OSC 84

OSCILLOSCOPE PM 3262

Subject: Alteration

This service information sheet must be used in combination with the PM 3262/05 service manual 9499 443 00502.

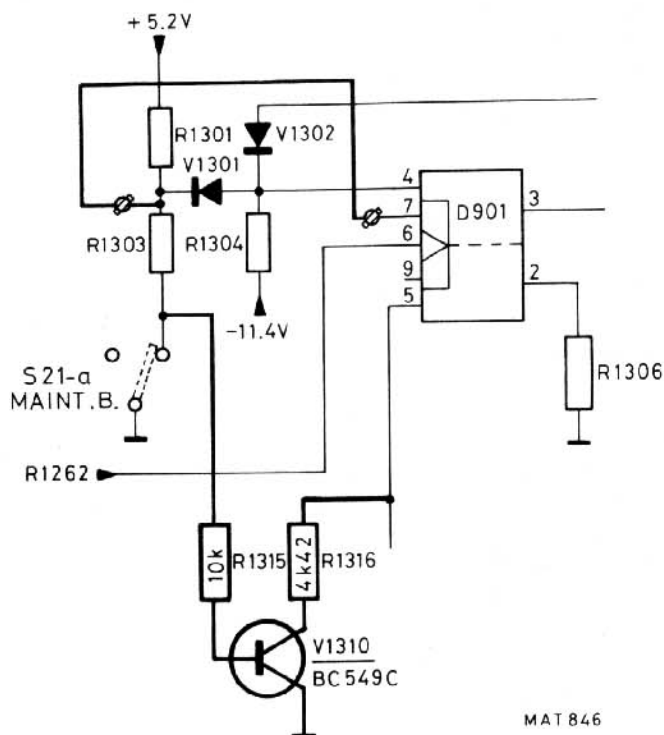
- A modification is introduced on unit 8 to avoid that DTB sweeps are too short and to avoid that in triggered DTB more than one DTB sweep is generated during one MTB sweep.

- A male contact pin is soldered in the hole of the print track between R 1303 and the cathode of V 1301.
- A connection wire is added between the new male contact pin and the male contact pin which is connected to point 7 of D 901.
- The undermentioned components are added to the circuit as shown in the figure.

V 1310	—	BC 549C	4822 130 44246
R 1315	—	10K	5322 116 54619
R 1316	—	4K42	5322 116 50556
